FCC Class II Permissive Change Application Letter

Product name : Wireless Exit Button
 FCC ID: 2ASIVPGA387
 Date of Grant: 05/11/2022
 Model No.: PGA387

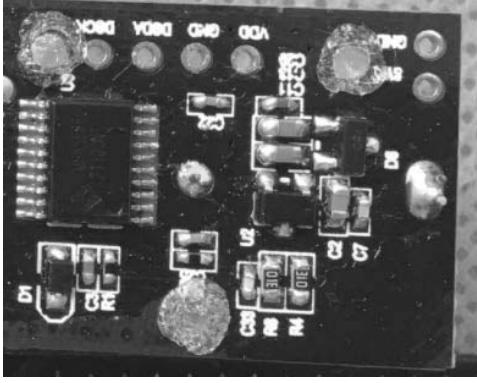
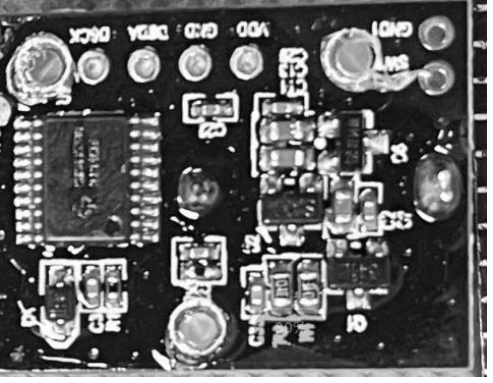
Change Contents: update the components on main board as below (The part to be added is MOS.):

Location	Old PCB of FCC ID: 2ASIVPGA387	New PCB of FCC ID: 2ASIVPGA387
MOS		
<p>MOS tubes are added to the main board to optimize the PCB layout; The circuit changes have no effect on the radio parameters.</p>		
<p>Modifications that do not change the fundamental RF characteristics and that do not degrade the unwanted emissions of the certified product, please refer to test report for more details; Modifications that do not change physical characteristics significantly. We attach new photographs to identify the modified product.</p>
